Design Exception #4 Reducing the Roadway Median Width

**I-70 West Vail Pass Safety and
Operations Improvements**

DESIGN EXCEPTIONS MEETING # 3
AUGUST 2, 2021

PROJECT LEADERSHIP TEAM MEETING # 9
AUGUST 6, 2021

Exhibit A -
Context Sensitive Solution
Median Design Exception
Mile Post 184.8 to 185.3
07-26-2021

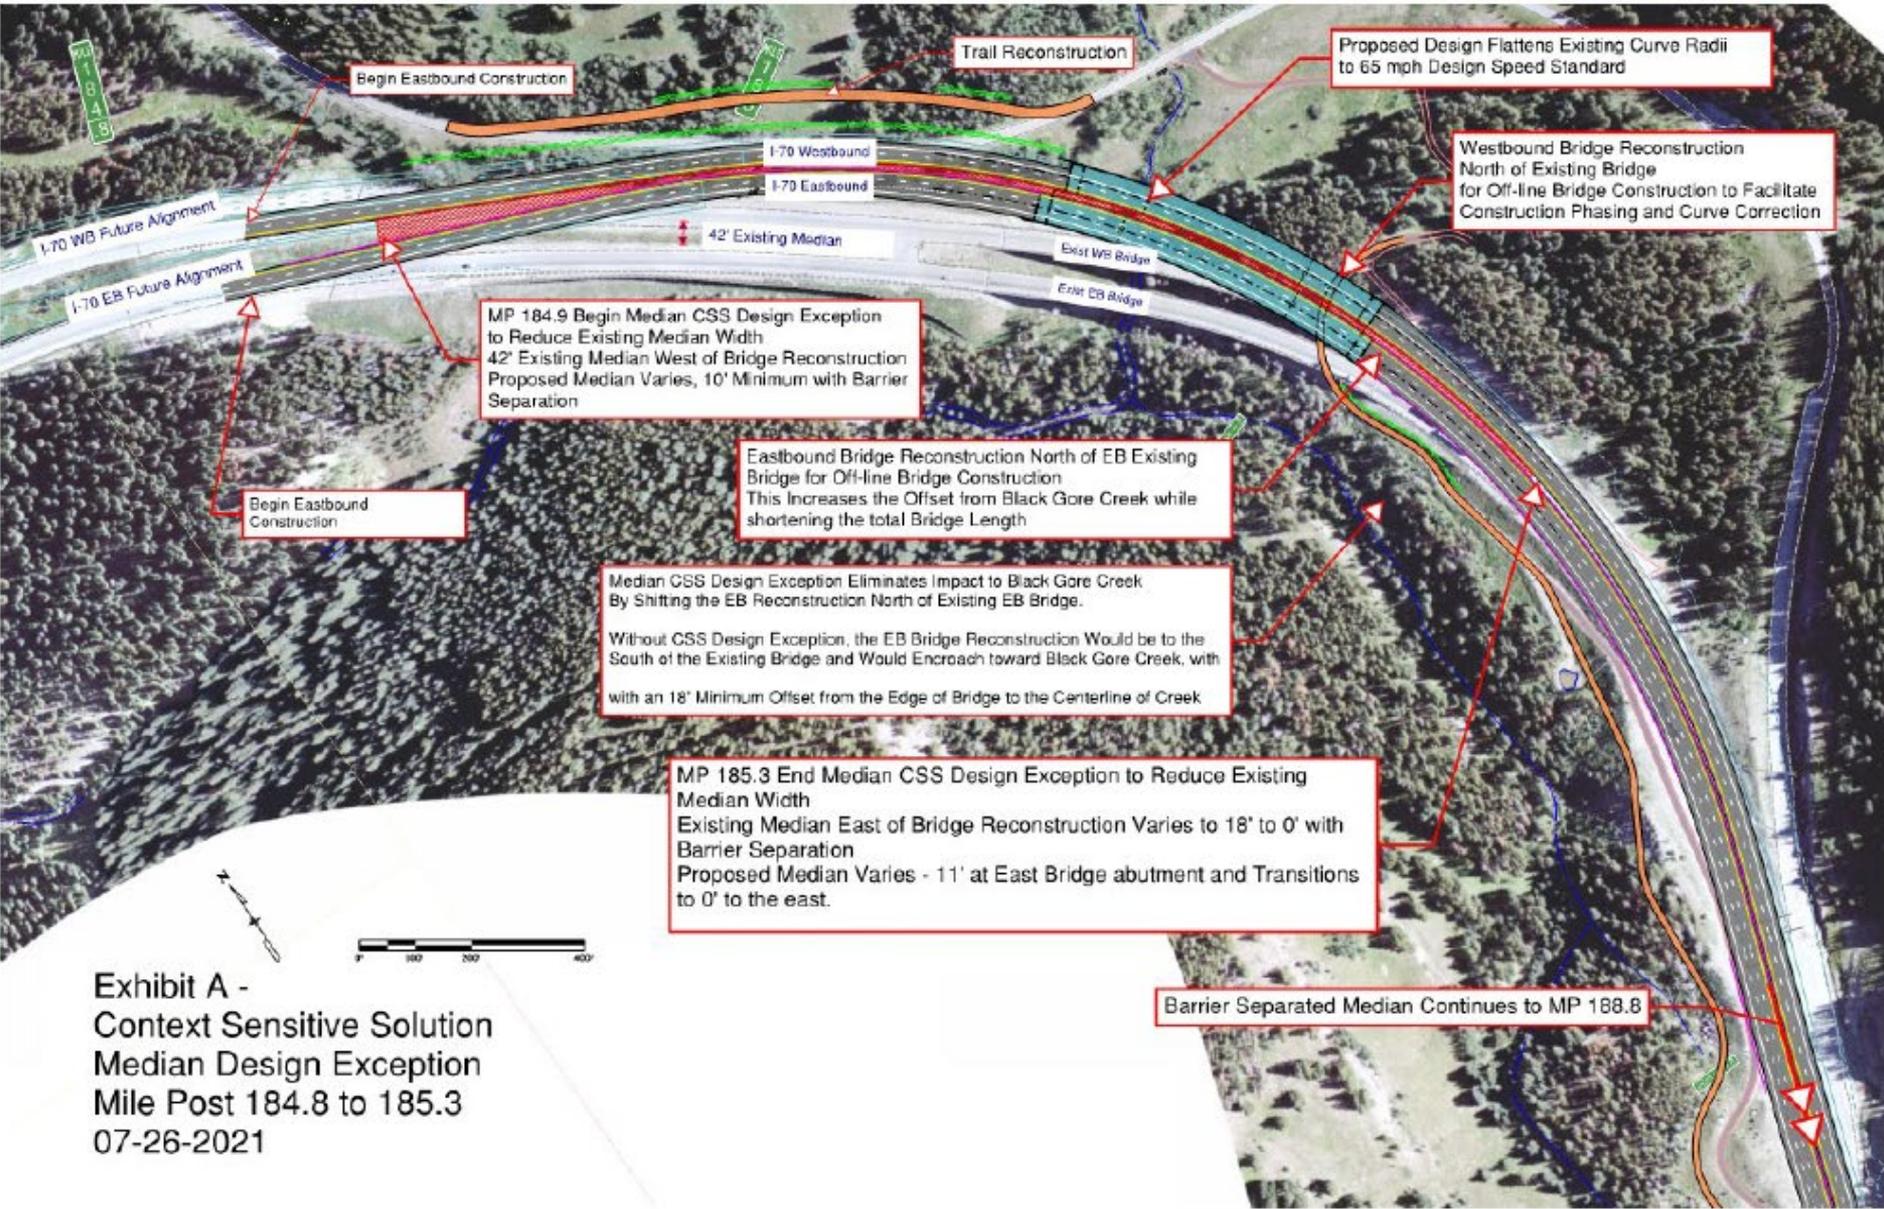
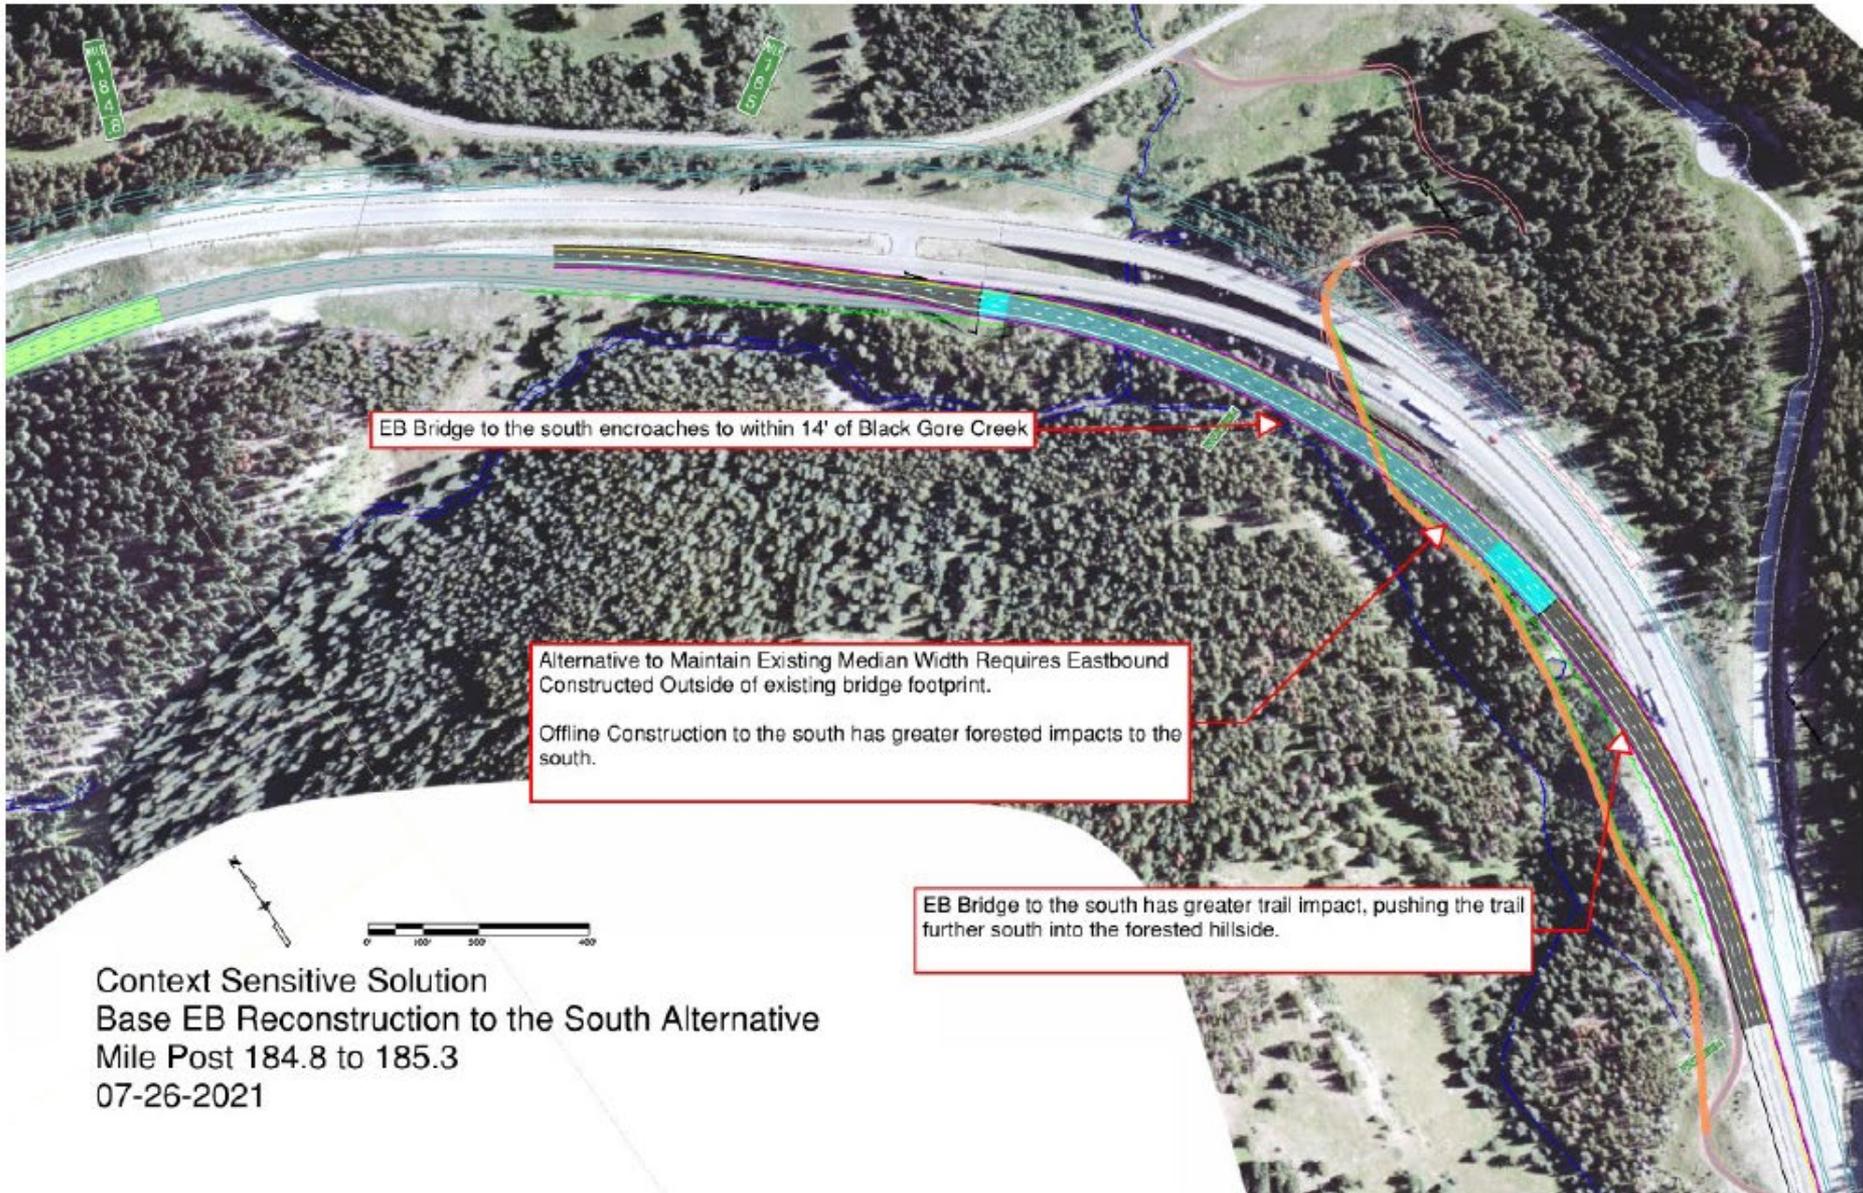
EB Bridge to the south encroaches to within 14' of Black Gore Creek

Alternative to Maintain Existing Median Width Requires Eastbound Constructed Outside of existing bridge footprint.

Offline Construction to the south has greater forested impacts to the south.

EB Bridge to the south has greater trail impact, pushing the trail further south into the forested hillside.

Reducing the existing median width reduces the impact to Black Gore Creek and forested areas to the south.

Shifting the EB bridge to the north reduces costs by \$23M by reducing the bridge length and wall height.

Extending the barrier a quarter of mile is consistent with next 4 miles of barrier separated roadway

Exhibit C (1 of 3)-
Context Sensitive Solution
Median Design Exception
Mile Post 188.8 to 190
07-20-2021

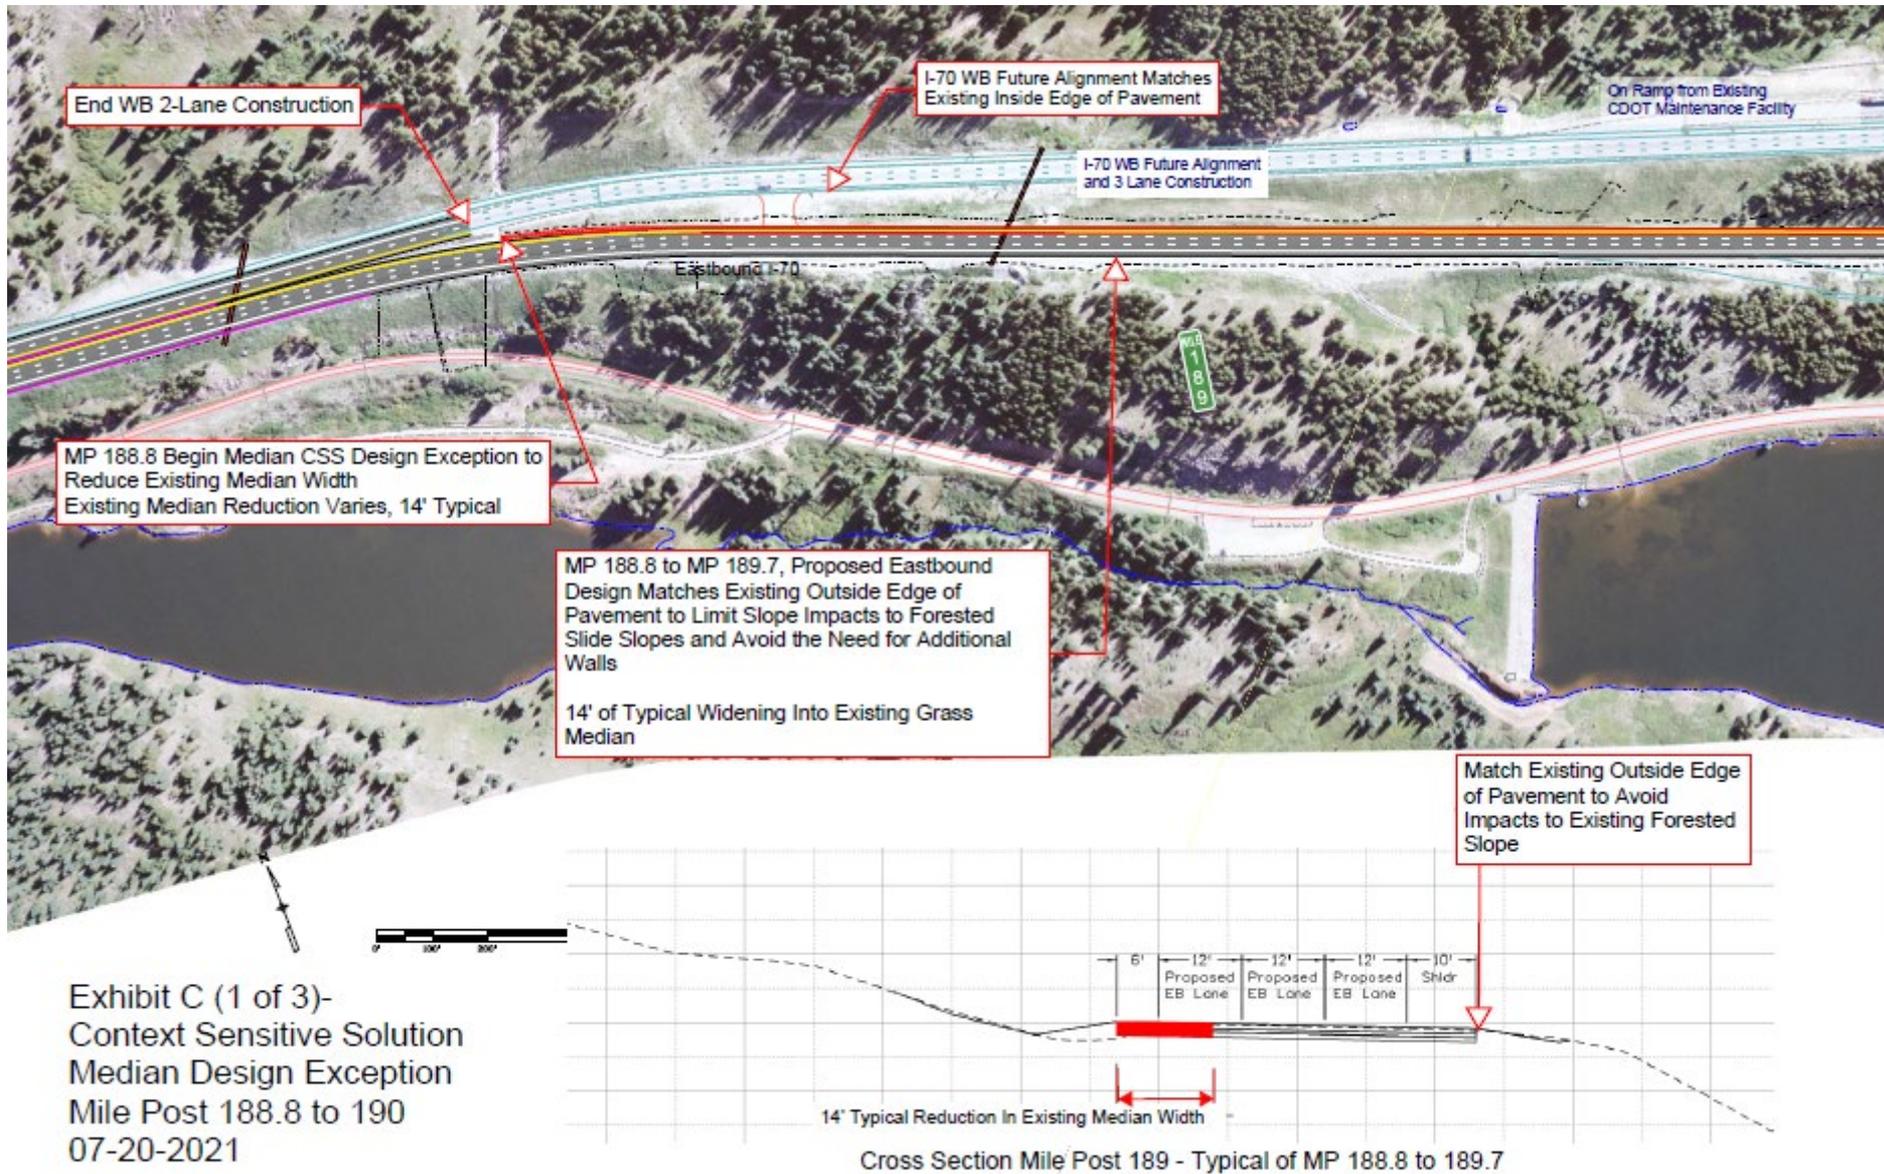
Matching the existing outside edge of pavement and widening 14' into the median is consistent with the roadway geometry.

This alignment allows the existing truck parking to remain in place.

Widening to the south would push the truck parking toward Black Lake No. 1 and the forested buffer between the parking and lake would be reduced.

Exhibit A -
Context Sensitive Solution
Median Design Exception
Mile Post 184.8 to 185.3
07-26-2021

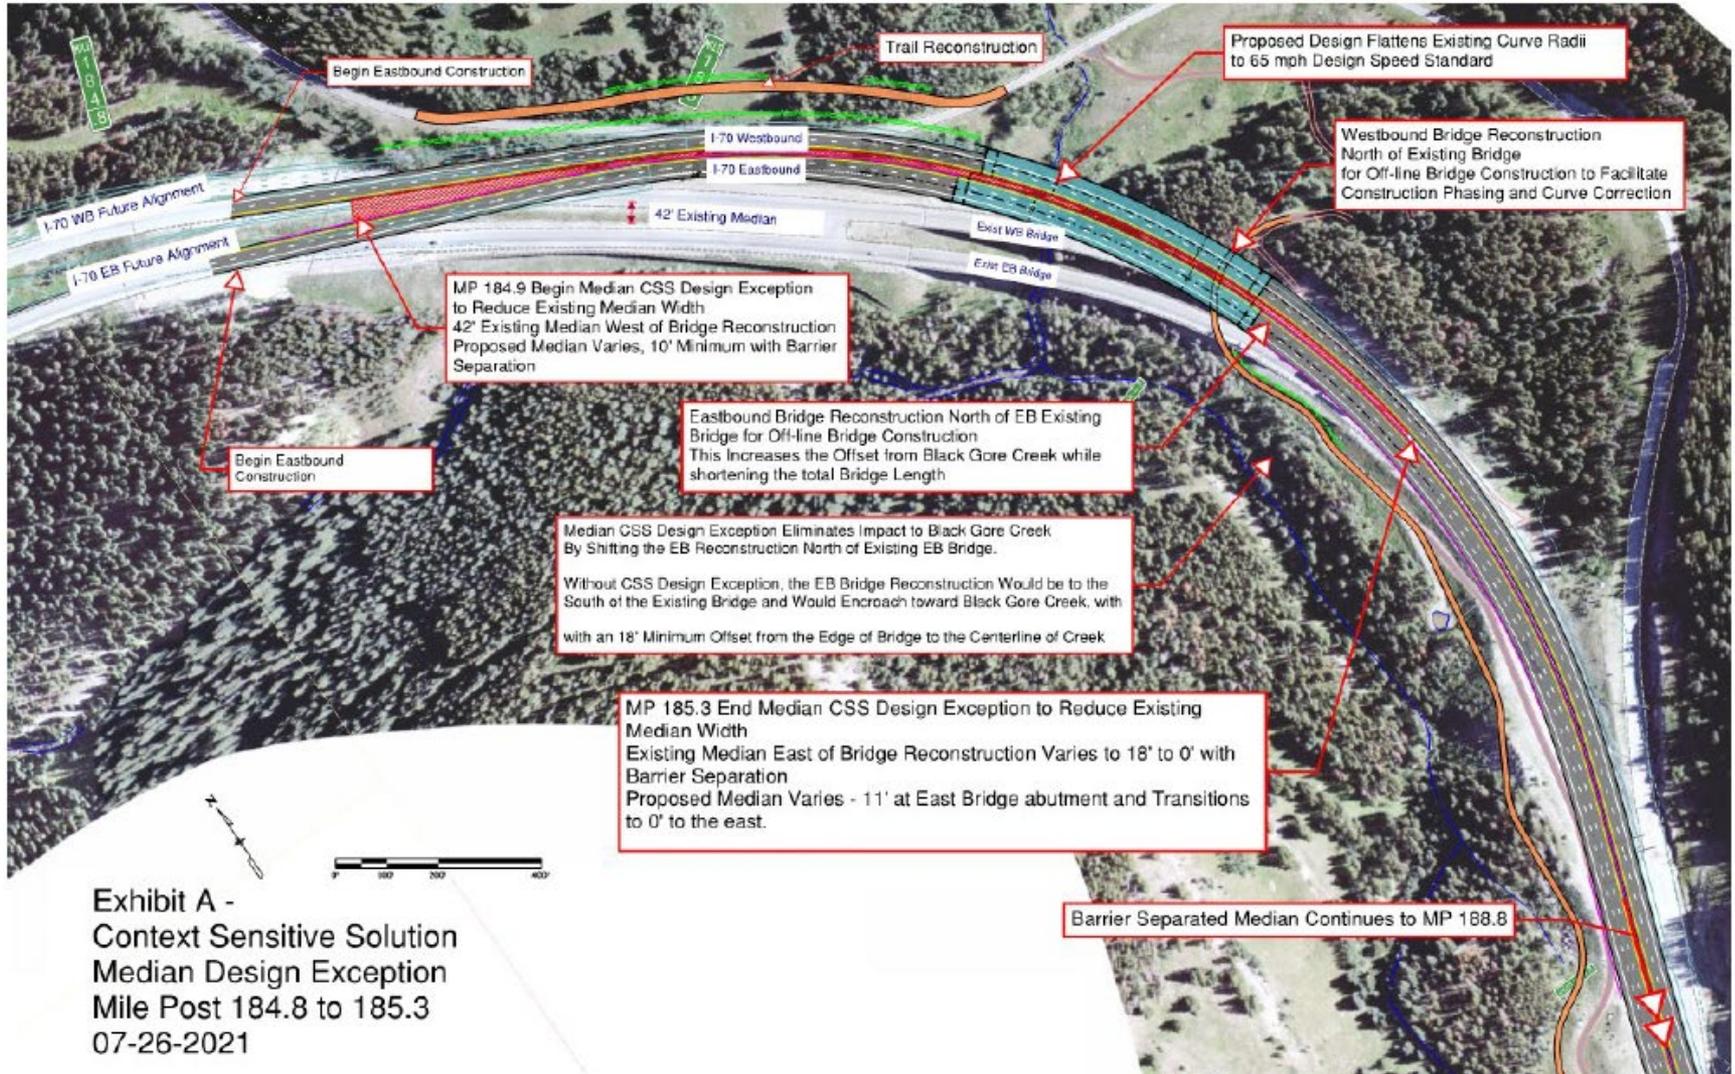
i. The first area for an exception is between MP 184.8 & MP 185.3 where our designers came up with a great idea to completely move the bridges to the north and rebuild both east and westbound. It provides a much better traffic solution and saves money on the corridor, but it does reduce the median.

Karen said this is in an area where there is a section of I-70 that the east and westbound is at the same level with very little median so we're just extending the section of highway that will have very little median.

What drove this design was really to pull the eastbound bridge away from Black Gore Creek and also to be able to build much shorter bridges we're moving everything to the north. The reason they're closer together is the way the phasing works. We would build the new westbound bridge first before moving it to its new configuration and that required the eastbound bridge to be really tight up against the westbound bridge. We also had to meet design standards for the radius of the roadway. Our justification for

One request from the group was to consider widening the median in one of the stretches between MP 184.8 & MP 185.3. We looked at it and it's just not feasible because this is where bridges are being moved and they have to stay together.

Exhibit B -
Context Sensitive Solution
Median Design Exception
Mile Post 186.9 to 187.4
07-20-2021

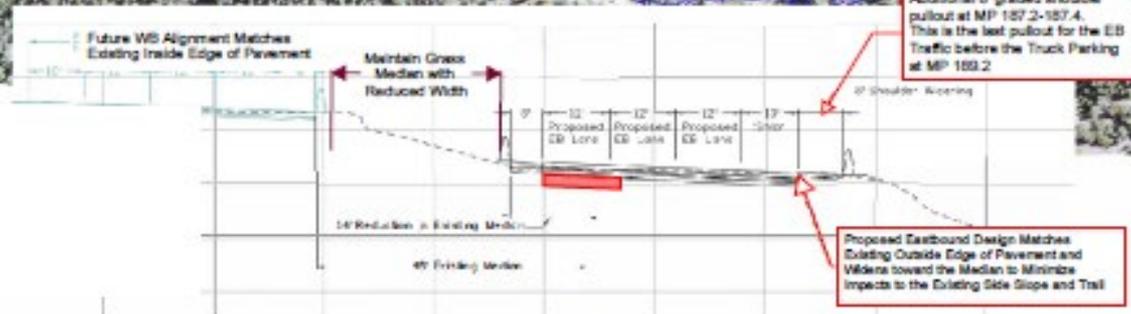
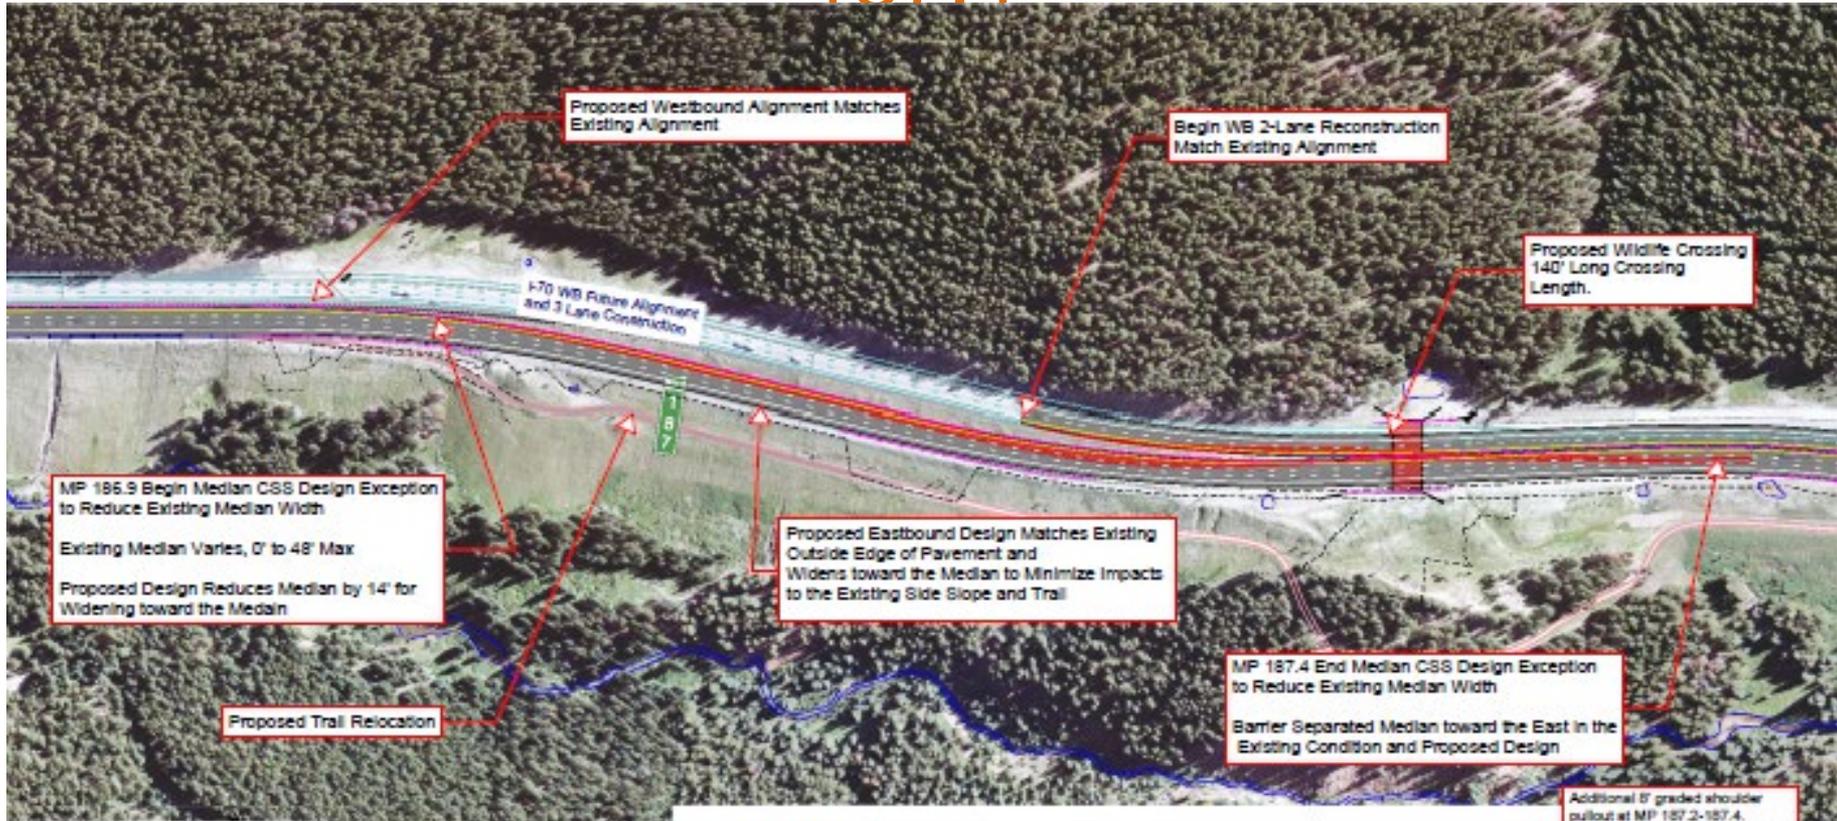
- ii. Karen said the second median reduction exception is between MP 186.9 and MP 187.4 Karen said one of the drivers in this location is we have a larger wildlife crossing on the east end and it's really important to keep those as short as possible. In this platform it was tricky trying to feather it in so there aren't impacts to the recreation trail on the south side. It just makes sense to widen into the median.

John said because we are adding a third lane and the designers held the edge of asphalt on the southern side there is less disturbance overall and fewer walls. It ties into the wildlife crossing which we have reduced the length by about 10' from the EA concept. Having no median here helps keep it shorter and that's true in a couple of the other wildlife crossings as well.
